### **REMARKS/ARGUMENTS**

App1. No. 09/742,036  
Amdt. dated 08/21/2003  
Reply to Office action of 07/02/2003

【図 7】

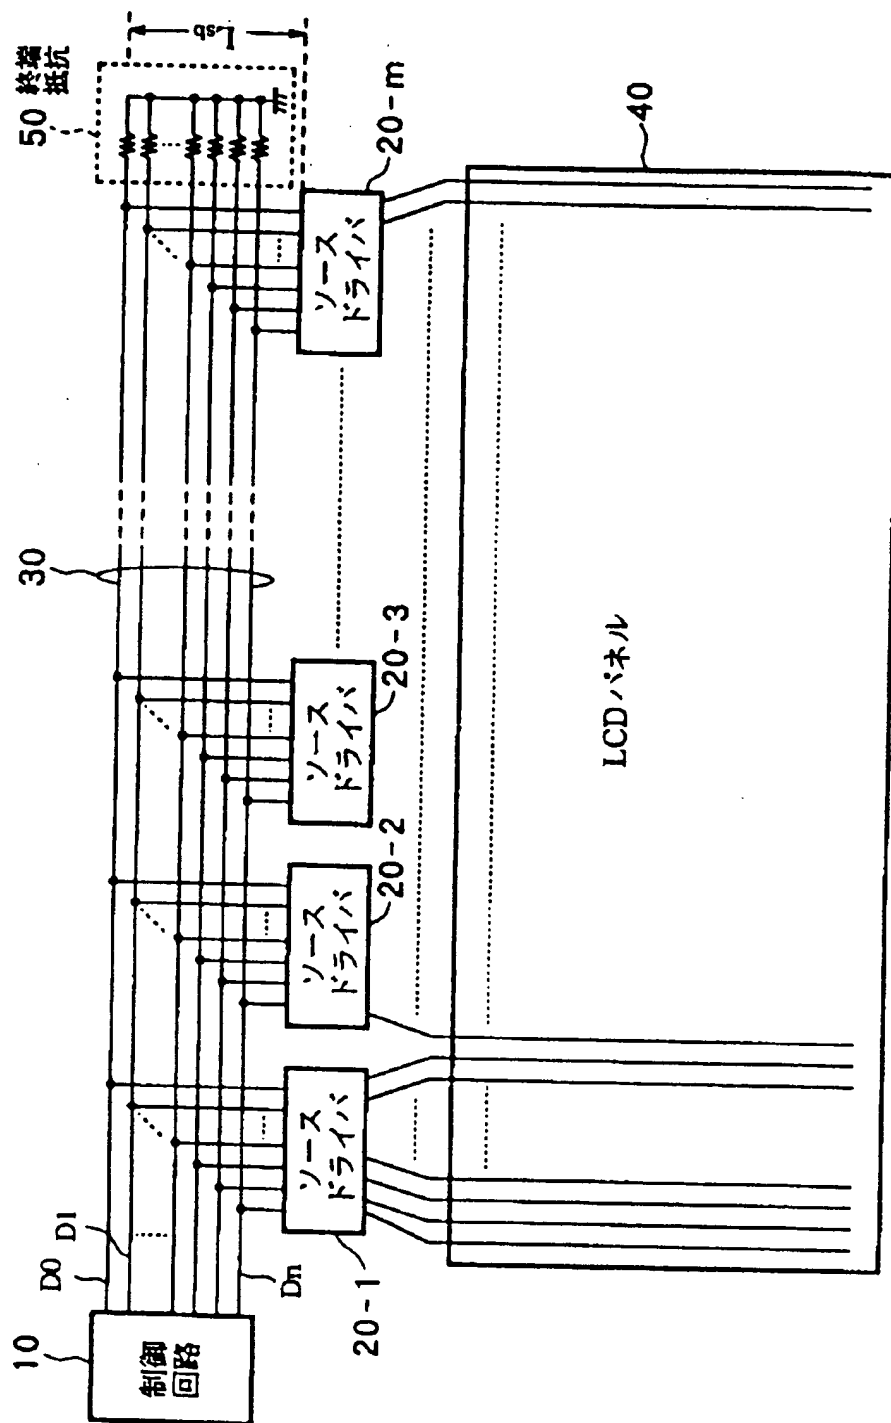
The Examiner states that Figure 7-9 should be designated by a legend such as --Prior Art-- because only that which is old is illustrated. These Figures have been so amended. The Examiner's approval of the drawing changes is respectfully requested.

PRIOR ART

Approved  
by examiner  
L.S. 12.08.03

【図9】

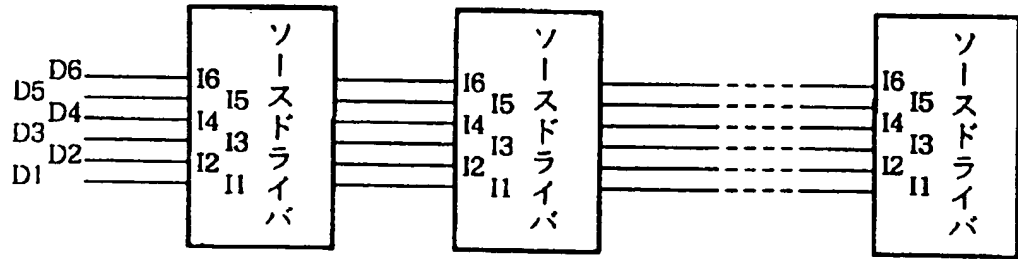
We cannot agree. Dingwall shows, in the Figure 4 recited by the Examiner, the same technology shown in Figure 9 of the present application, which is acknowledged prior art. This only works where the inputs to the chip are on one of the long dimensions of the chip and the outputs are on the short dimensions of the chip (not shown in Figure 4 of Dingwall) which is not the case here. Because of the high switching frequency of the output lines, it is not practical to crowd them to have the inputs come along the short end of the chip and the outputs come along the long end of the chip in the present invention. These lines need greater spacing than this would provide. Furthermore, Mical is even further from the present invention. At top of col. 6 of Mical, is a description of a resolution-enhancing subsystem which includes a crossover unit 151 for selectively transposing part of the Px signals, first and second delay registers A and B couple to the crossover unit for generating previous column signals. Thus, although the reference mentions a cross-over unit, it is clear that this is for a completely different purpose and totally unrelated to the present invention. With respect to Cha, it is respectfully submitted that the wiring 30 and the wiring 20 are on different circuit boards which are attached to the integrated circuit chip 12 in Figure 1 and therefore comprise, in effect, a multilevel wiring, which is the problem sought to be overcome by the present invention. It should be noted that Claim 11 recites a wiring substrate having a single level of wiring thereon.

PRIOR ART
